L-85-190

Re: Turkey Point Units 3 & 4
Docket Nos. 50-250 & 50-251
SPDS Implementation Plan and
Parameter Selection Report
Request for Additional Information
NRC TAC Nos. 51293 and 51294

**RESPONSE TO NRC REQUEST
FOR ADDITIONAL INFORMATION
ON THE TURKEY POINT SPDS**

FIGURE 2

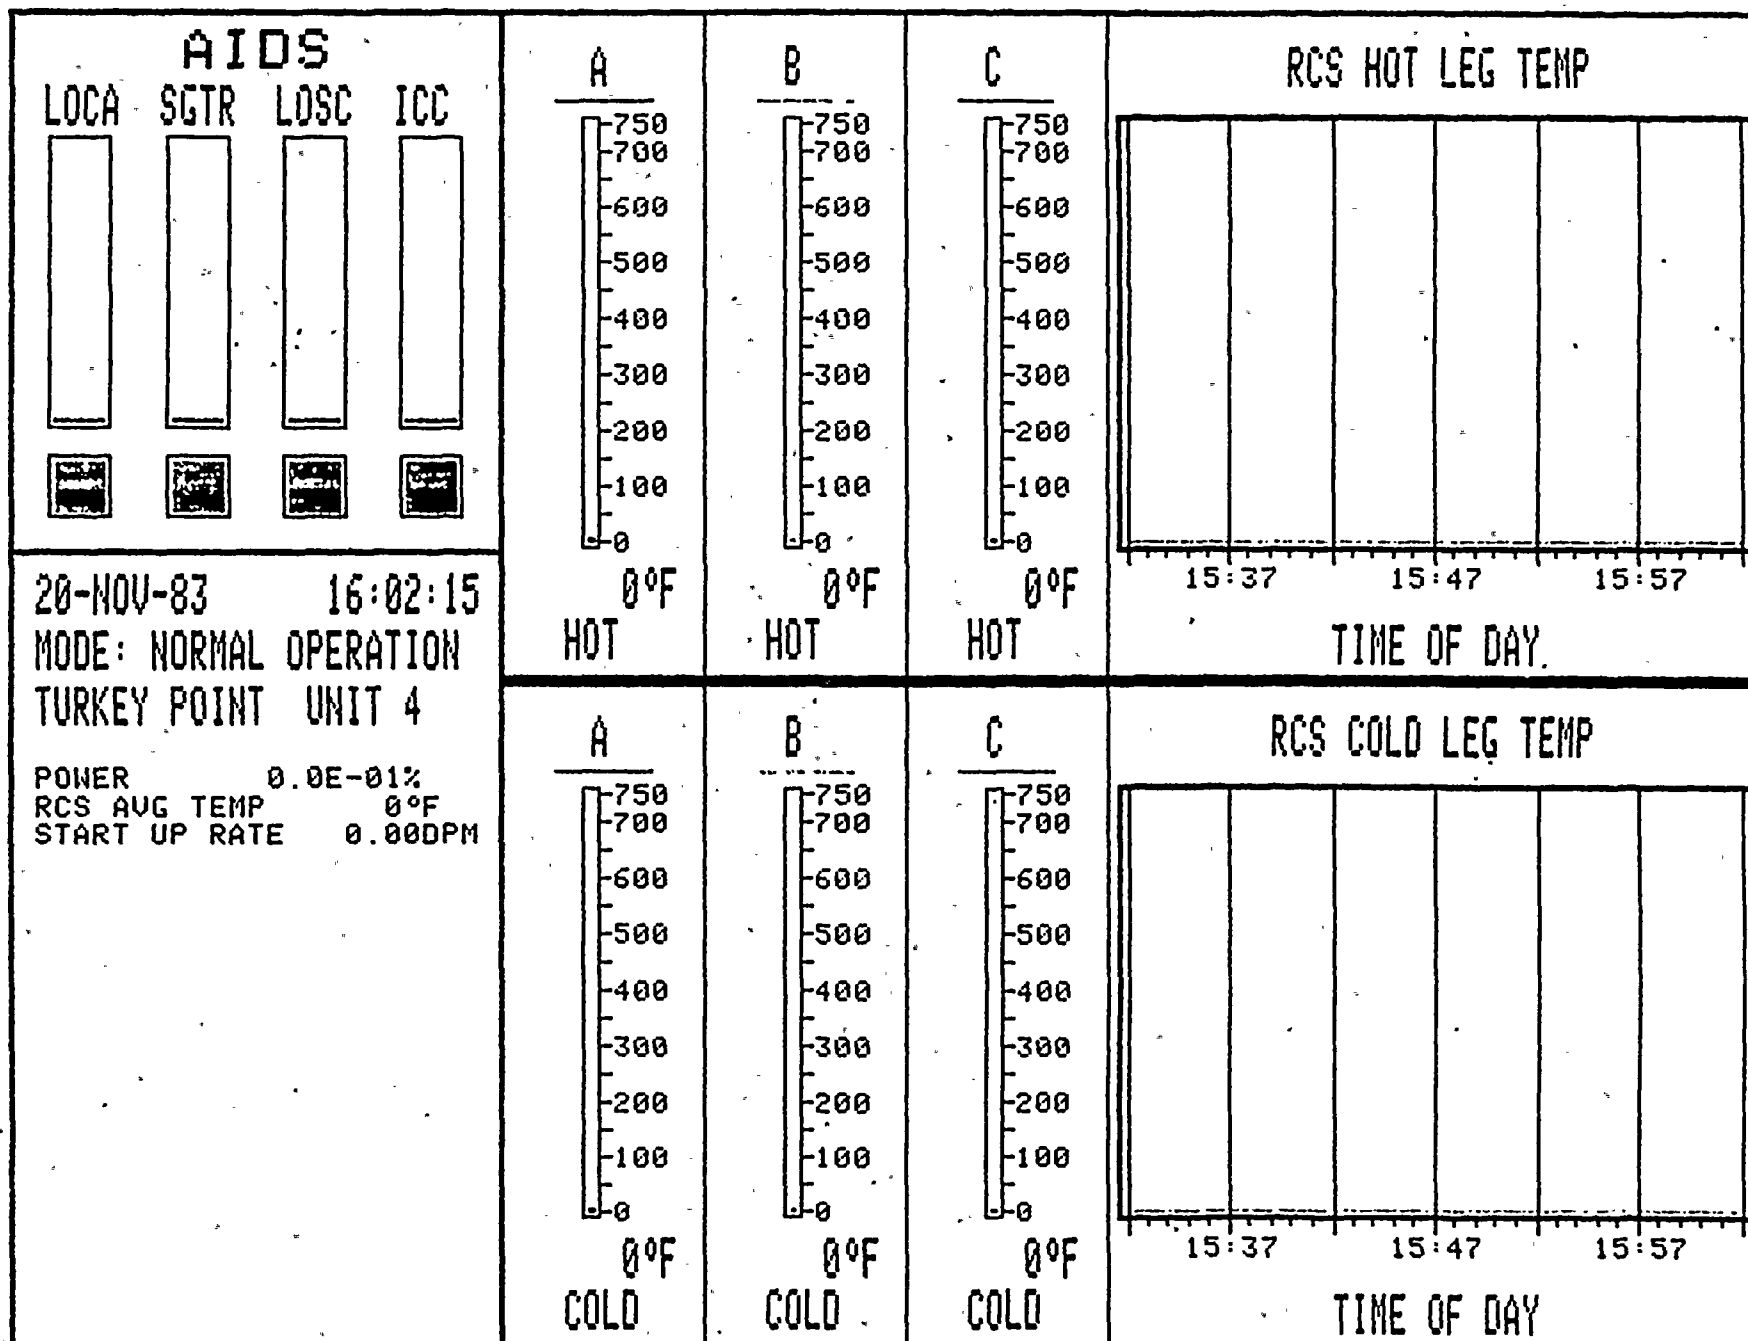
Hot leg temperature is an indicator used in the Emergency Response guidelines (ERGs) to determine the viability of natural circulation as a mode of heat removal. Core Exit Thermocouple (CET) indication is used on the Turkey Point SPDS instead of hot leg temperature as an indication of RCS temperature leaving the core. For a natural circulation event, the CET value would be essentially identical to the hot leg value. In addition, the CETs provide valuable indication of inadequate core cooling events where the core may be uncovered.

Further, hot leg temperature can be displayed on the SPDS CRT by using the dedicated function key pad located near the control board. A sample of this display is provided by Figure 2. Because this parameter was not part of our original SPDS parameter list, it will not be available on the same schedule as SPDS. Hot leg temperature will be provided to SPDS on the same schedule as SAS.

FIGURE 3

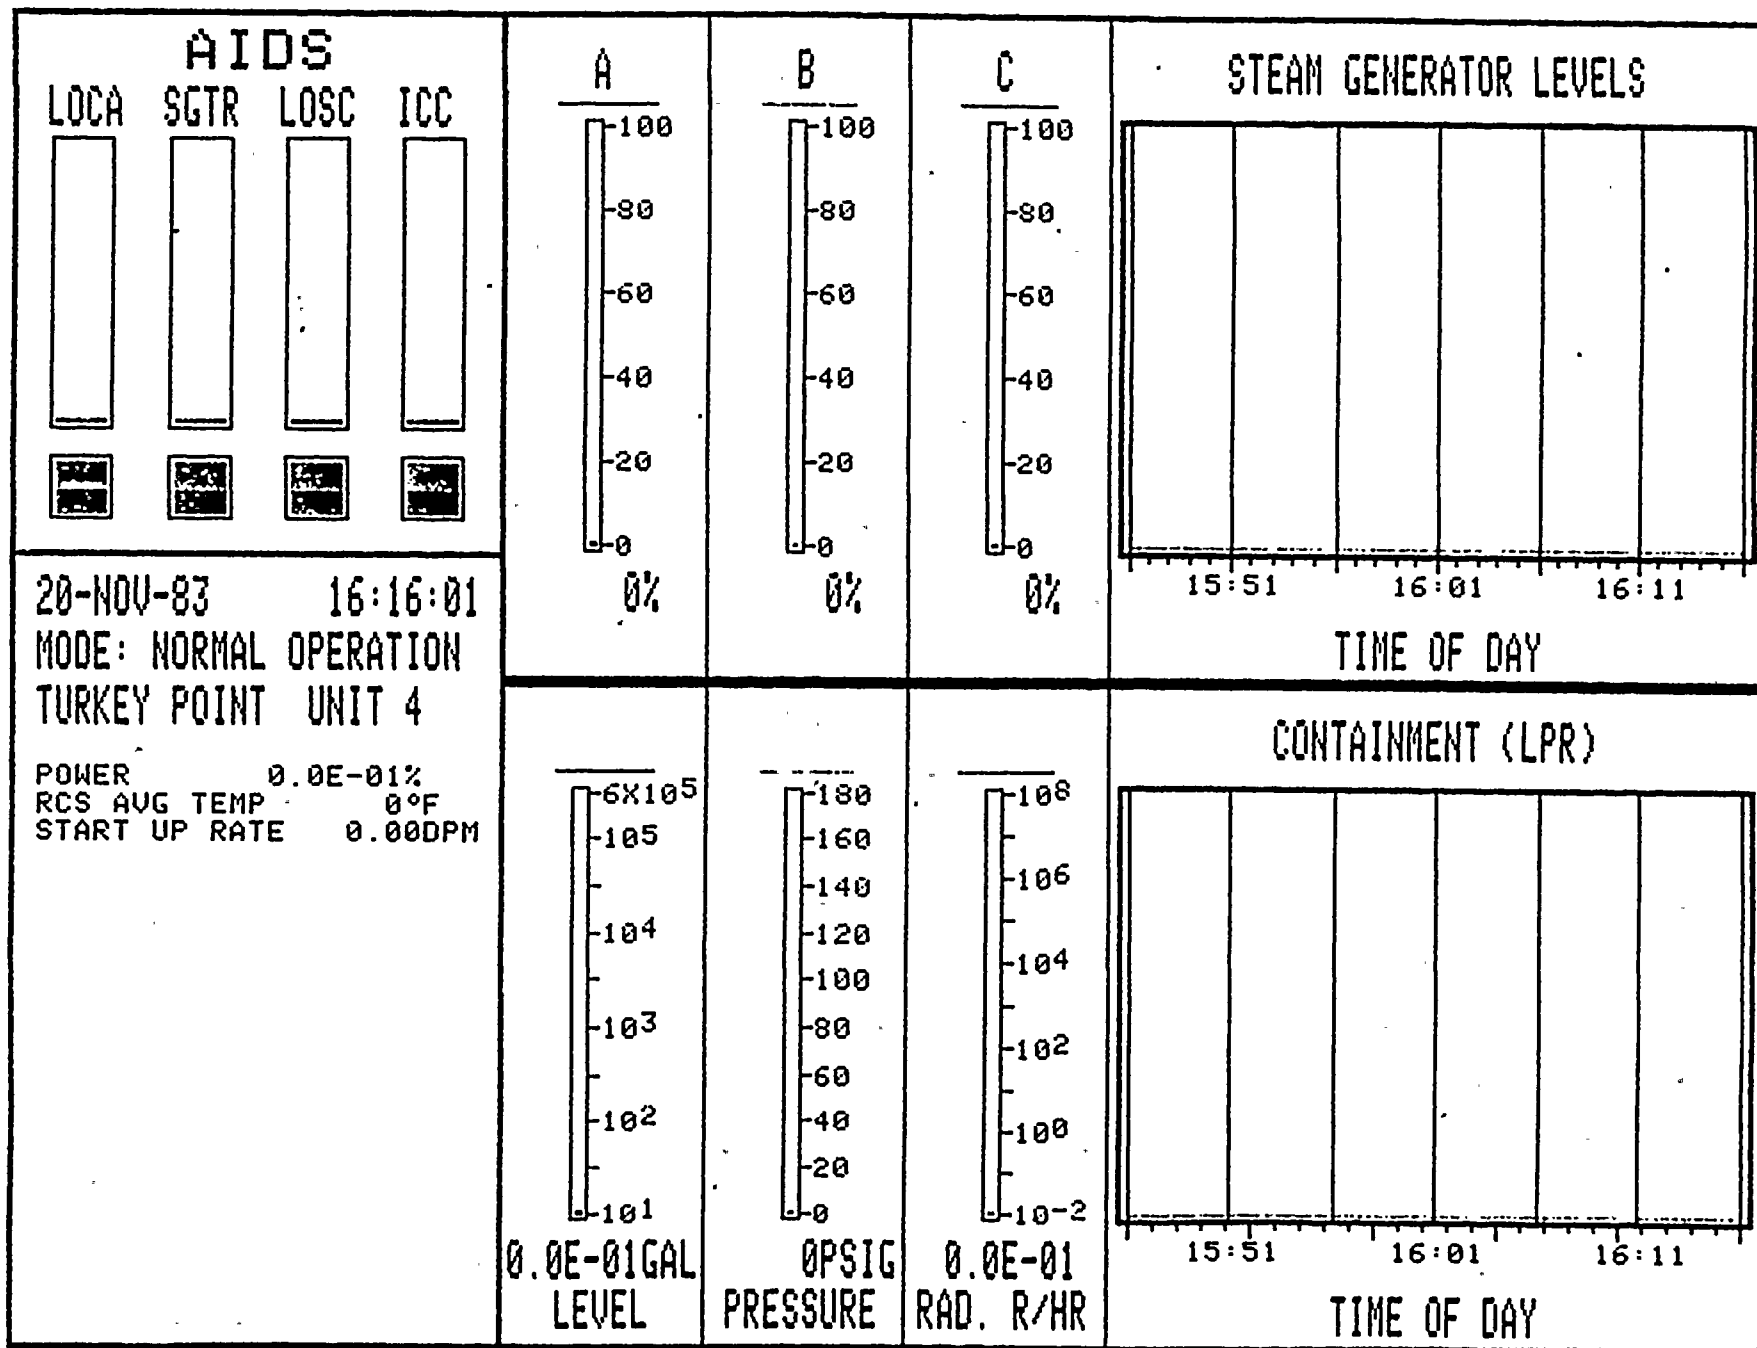
Containment sump level is one of three inputs to the containment environment target on the Turkey Point SPDS. Should any of these parameters go out of their allowable range, the containment environment target will turn red. The operator may then display each of the inputs for this target (including sump level) by use of the dedicated function keyboard located near the control board. A sample of this additional display is shown by Figure 3.

Like containment sump level described above, containment pressure is an input parameter to the containment environment target. Should containment pressure exceed set limits, the containment environment target will turn red. Precise information on containment pressure may then be shown on the SPDS through use of the dedicated SPDS key pad located near the control board. A sample of the display available for containment pressure is shown by Figure 3.
